Forty-third session

Establishment of common principles and technical requirements for pan-European River Information Services (RIS): International Standard for Tracking and Tracing on Inland Waterways (VTT)

Draft revised International Standard for Tracking and Tracing on Inland Waterways (VTT) (Resolution No. 63)

Transmitted by the Chair of the VTT Expert Group

Figure 1

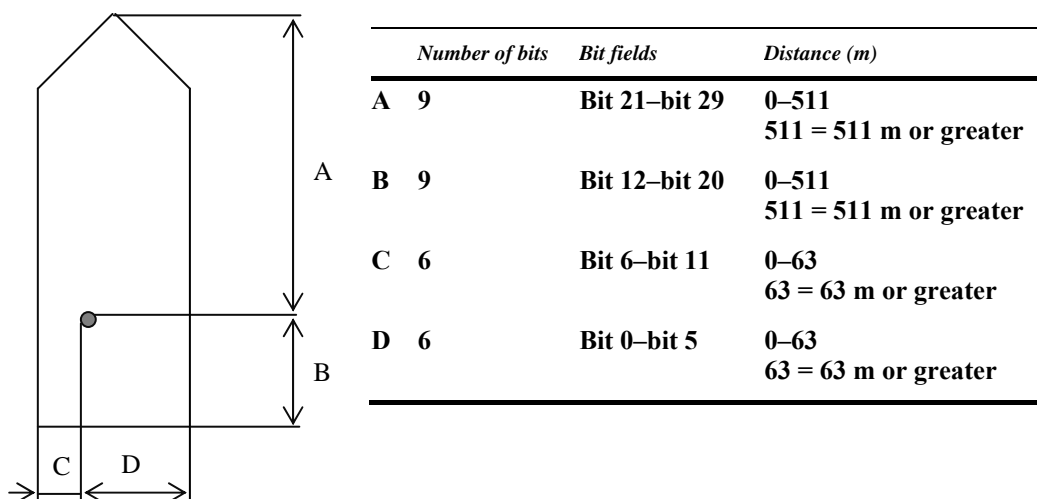
2.4.2.1 Reference point for reported position and overall dimensions of ~~ship~~ **vessel or convoy**

The dimension A should be in the direction of the transmitted heading information (bow).

D.2 Inland waterway static Ship vessel data

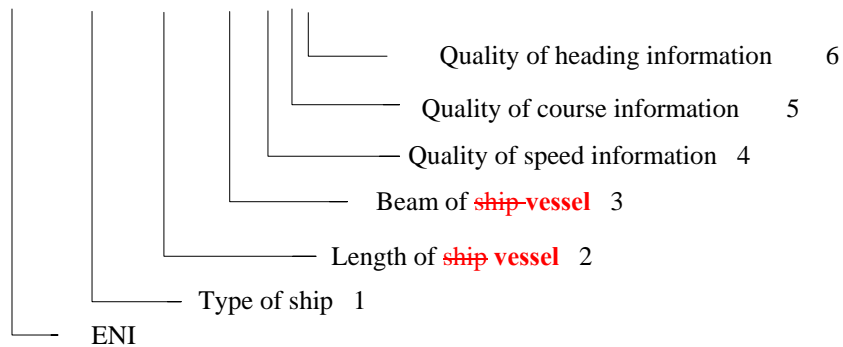
This sentence is used to enter inland navigation static **ship vessel** data into an Inland AIS unit. For setting the inland static **ship vessel** data the sentence \$PIWWSSD with the following content is ~~proposed~~ used:

- Note 1: **ERI** ship type according to ERI classification (see annex E)
- Note 2: length of **ship vessel** 0 to 800,0 metre
- Note 3: beam of **ship vessel** 0 to 100,0 metre
- Note 4: quality of speed information 1 = high or 0 = low
- Note 5: quality of course information 1 = high or 0 = low
- Note 6: quality of heading information 1 = high or 0 = low

D.3 Inland waterway voyage-related vessel data

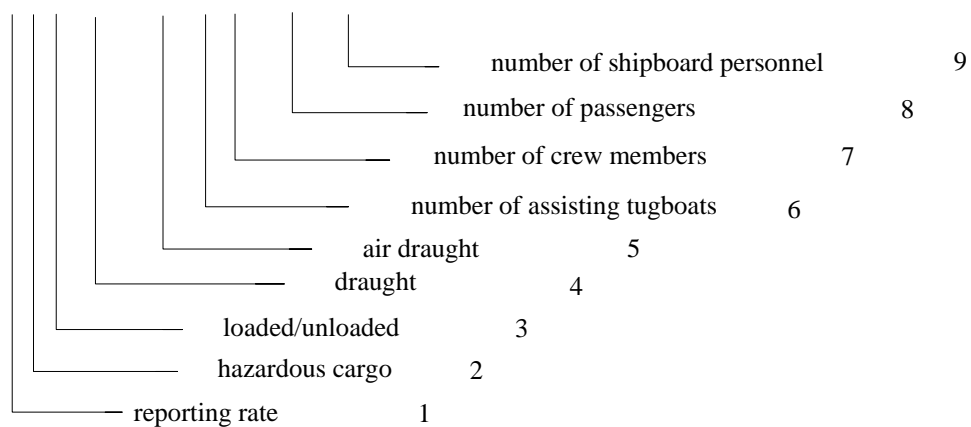
This sentence is used to enter inland navigation voyage-related **ship vessel** data into an Inland AIS unit. For setting the inland voyage-related data the sentence \$PIWWIVD with the following content is ~~proposed~~ used:

- Note 1: See Table 2.5 Reporting rate settings, default setting: 0
- Note 2: number of blue cones/**lights**: 0–3, 4 = B flag, 5 = default = unknown
- Note 3: 0 = not available=default, 1 = loaded, 2 = unloaded, rest not used
- Note 4: static draught of **ship vessel** 0 to 20,00 meters, 0 = unknown = default, rest not used
- Note 5: air draught of **ship vessel** 0 to 40,00 meters, 0 = unknown = default, rest not used
- Note 6: number of assisting tugboat 0–6, 7 = default = unknown, rest not used
- Note 7: number of crew members on board 0 to 254, 255 = unknown = default, rest not used
- Note 8: number of passengers on board 0 to 8190, 8191 = unknown = default, rest not used

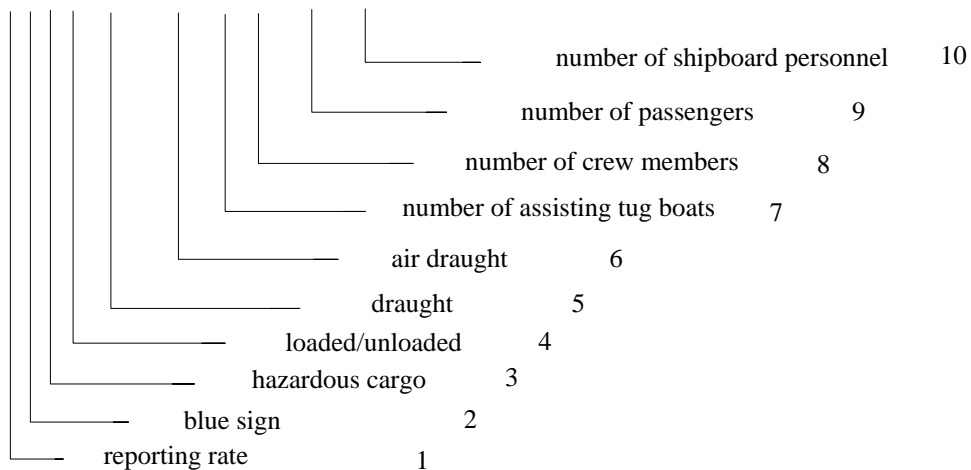
Remark: The ~~former proposed~~ input sentence \$PIWWVSD, **which was formerly** used in Inland AIS units developed prior ~~this standard~~ **these technical specifications**, contains the parameter field “blue sign” which may raise conflicts with the parameter field “regional application flags” in the \$--VSD sentence according to IEC 61162-1:VSD-AIS voyage static data.

It should no longer be implemented in new AIS transponders. However, for compatibility reasons, it should be supported by external applications.
